# ECO4 scoring methodology: part 1

## British Gas response

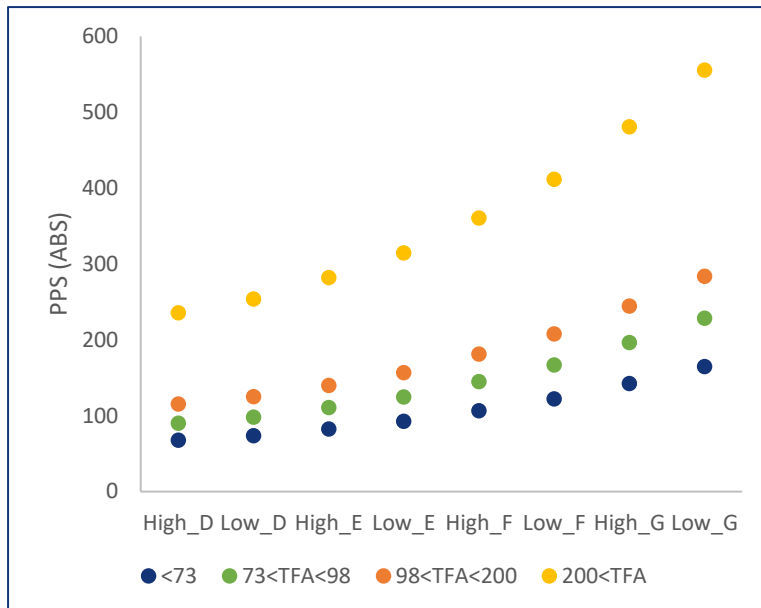
And there is a similar observation on partial scores. The chart below shows the average PPS at each SAP band for the proposed floor areas. The three main floor area categories have reasonable improvements as floor size increases. The largest floor area category offers up to double the return.

We can see how the group makes sense analytically, in the models. However, we have concerns of unintended consequences in practice. Whilst there may be homes with such large floor areas in the housing stock, we don't believe that these are proportionately represented in the ECO eligible population.

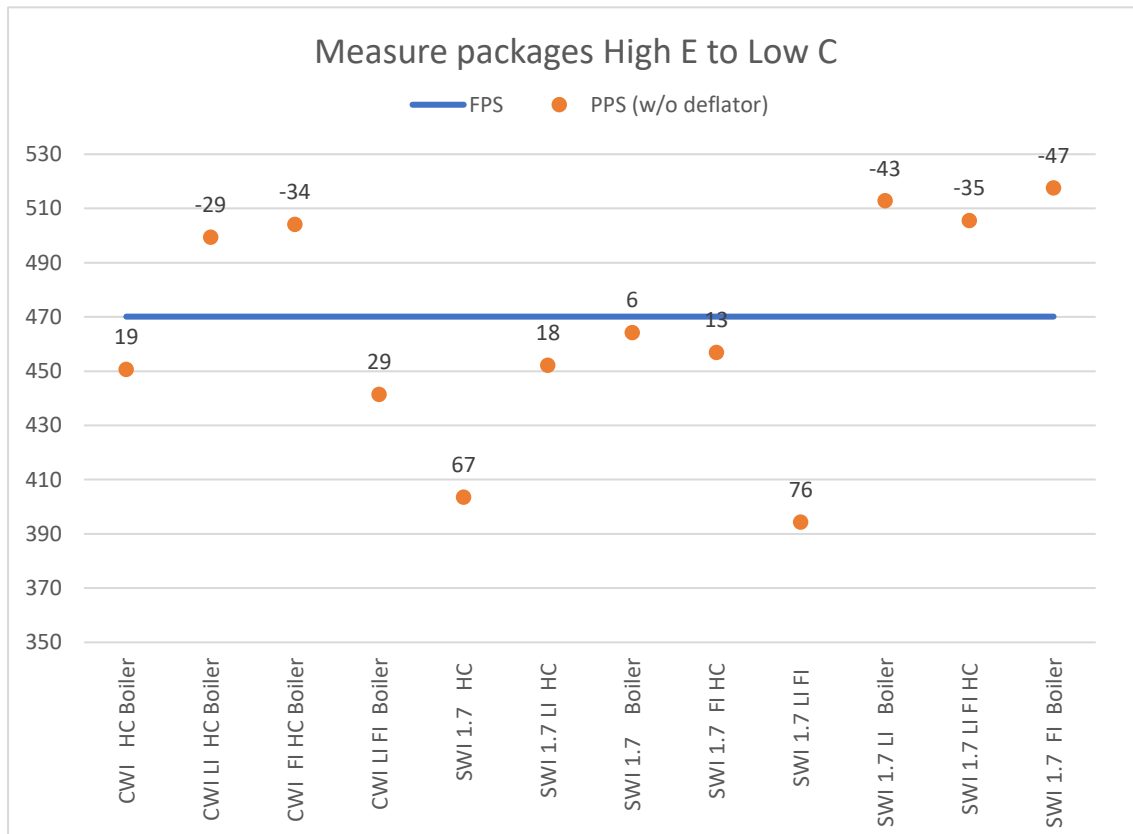
We believe it would be better to use the partial project scores (we prefer the term: measure scores) without deflators when the MR is met (or exempt). In some cases the summation of the measure scores will be higher than the FPS model, in some case lower. We show examples in the graph below based on floor area 73-98m<sup>2</sup>, starting band E, packages totalling 18-24 SAP points.

The variance between the two models is small and not material enough to justify switching to a separate scoring system.
